CULTURAL RESOURCES OFFICE PRESERVATION BOARD

REGULAR MEETING MONDAY NOVEMBER 26, 2012 — 4:00 P.M. 1520 MARKET ST. #2000

SUBJECT: Preliminary Review to demolish existing 5-story building

Address: 1105-09 Olive

UPPER PORTION OF EAST WALL

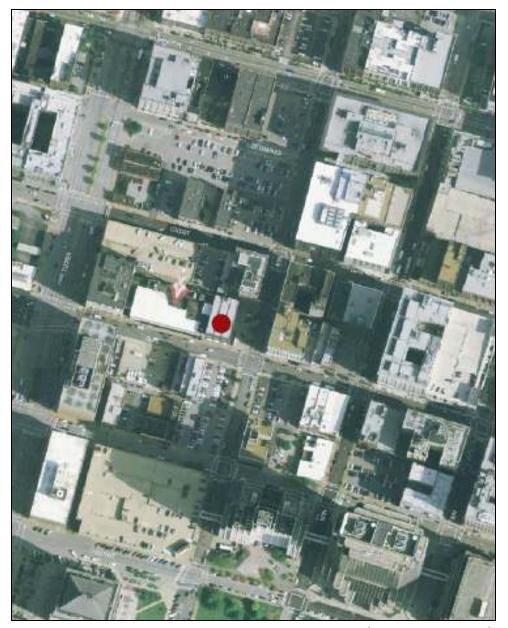
- Sound structures with apparent potential for adaptive reuse, reuse and or resale shall generally not be approved for demolition unless application of criteria in subsections A, D, F and G, four, six and seven indicates demolition is appropriate. Ordinance #64689 defines "sound" to mean that visible portions of exterior walls and roofs appear capable of continuing to support their current loads for six months or more. The exterior inspection of the building indicates that it meets this definition of soundness. The upper stories of the Olive façade attest to the quality of the brick and masonry craftsmanship and display few indications of loss of masonry elements or needed maintenance. The exposed party wall exhibits water damage near the top of the south side; parapet coping is missing and so water damage continues. Overall, this wall needs maintenance and repair: at a minimum, repointing and perhaps some brick relayment. One opening in the east wall, which has been closed with recessed brick, has lost several unsupported voussoirs from its rowlock arch, a condition that does not appear to be recent. The east bay of the

north wall exhibits step cracks, some loss of arch brick, and evidence of earlier inappropriate re-pointing as well as a number of exposed mortar joints in need of additional repointing. The piers of the first story of the south façade, which has been reconstructed, have cracked brick that indicates that the veneer is delaminating from the substrate. These conditions are evidence of deferred maintenance and perhaps destabilizing conditions, but do not suggest that the building cannot stand for another six months.

As the building has stood for nearly ten years since the alleged destabilization by the excavation for the adjacent construction project, and the exterior examination of the building reveals conditions that relate to deferred repairs and maintenance, it is difficult to conclude that this building does not meet the definition of "sound."

FRONT ELEVATION SHOWING PROPOSED BUILDING AND HEIGHT OF ADJACENT BUILDING

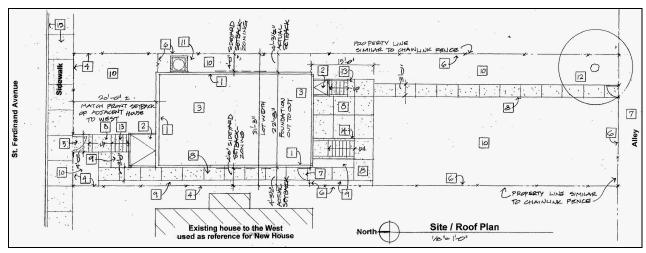
<u>Complies</u>. The majority of the buildings on the block are one-story with raised basement houses. The proposed building is within 92 percent of the height of the building next door. The distance above front-grade elevation for the first floor varies widely on the block and the proposed design falls within that range.

EAST SIDE ELEVATION - 4' BRICK RETURN, REMAINING WALL TO BE BRICK-COLOR VINYL SIDING

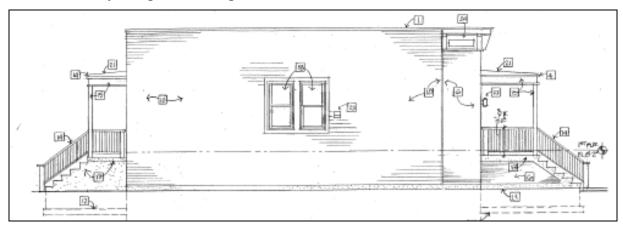
<u>Partially complies</u>. The building front will be brick with 4-foot returns at the sides. The remainder of the house is proposed to be a brick-colored vinyl siding. The east side of the house will be exposed once the demolition of 4270 W St. Ferdinand is completed.

APPLICANT'S PLAN FOR THE PROPERTY IF DEMOLITION IS APPROVED (HISTORIC HOUSE SHOWN SHADED)

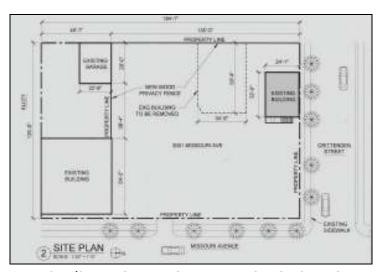
The plan for the property, as proposed by the Reinickes, consists of fencing the lot at the rear alley and at the south property line with a privacy fence and adding a low wrought-iron fence to the Crittenden and Missouri frontages. The Reinickes state that they intend in the future to rehabilitate the historic house on Crittenden Street, which is a Merit Building

That the Preservation Board agree to the demolition of the factory building, with the condition that the plan for the subsequent treatment of the property be revised to include the steps needed to be taken to preserve and appropriately mothball the historic house on the property, a Merit Building, until its rehabilitation.
